**Independent examination of  
the Cranbrook Local Plan –  
Stage 2 Questions**

**Response to Questions AQ17-  
AQ19 (Additional Highway  
Detail/Sustainable Transport)**

*Prepared For*  
**Cranbrook LVA**

## Response to AQ17 & 18 on behalf of Farlands LVA LLP

**Figure 1.1 Cobden area S278 works**

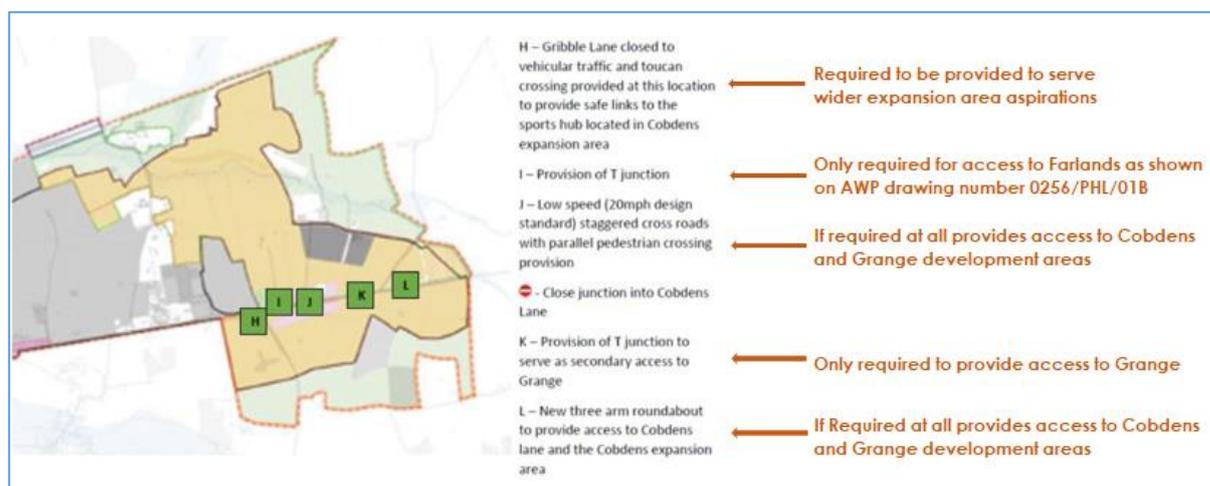
- 2.6 Much of the works included as “S278 Works” would normally be provided as part of a developer’s development infrastructure. The works proposed at the Cobdens expansion land is set out in a diagram on p15 of the IDP. The necessity for those works has been reviewed and a commentary (**in orange**), based upon the figure in the IDP, is set out in Figure 1.1 below:
